[Docket No. 2002–SW–15–AD; Amendment 39–12817; AD 2002–14–17]

Airworthiness Directives; Eurocopter Deutschland GmbH Model EC135 Helicopters

ACTION: Final rule; request for comments.

Crack inspection on main rotor hub-shaft
Figure 1

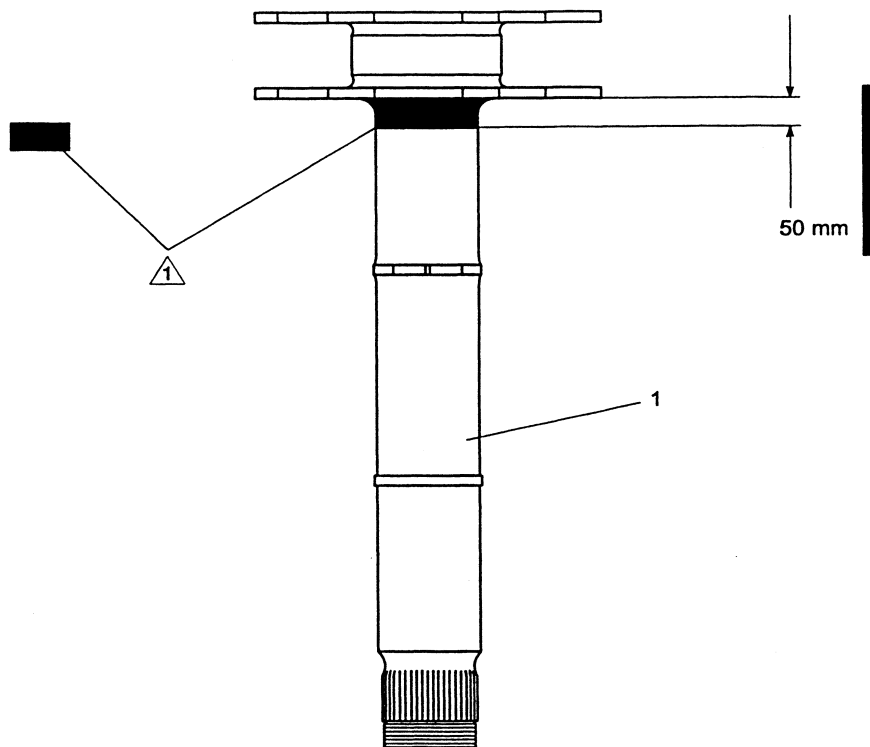
(a) Before further flight, clean and visually inspect the shaft for cracks in the area as shown in the following Figure 1:

△ 1 Inspect marked area i.a.w. crack inspection procedure described.

(b) Within 10 hours time-in-service (TIS) after accomplishing the visual inspection required by paragraph (a) of this AD, clean and dye-penetrant inspect the shaft for cracks in the area as shown in Figure 1 of this AD.

(c) Thereafter, visually inspect the shaft for cracks in accordance with paragraph (a) of this AD at intervals not to exceed 15 hours TIS, or dye-penetrant inspect the shaft for cracks in accordance with paragraph (b) of this AD at intervals not to exceed 100 hours TIS.

(d) If a crack is discovered during any shaft inspections, remove the shaft and replace it with an airworthy shaft.
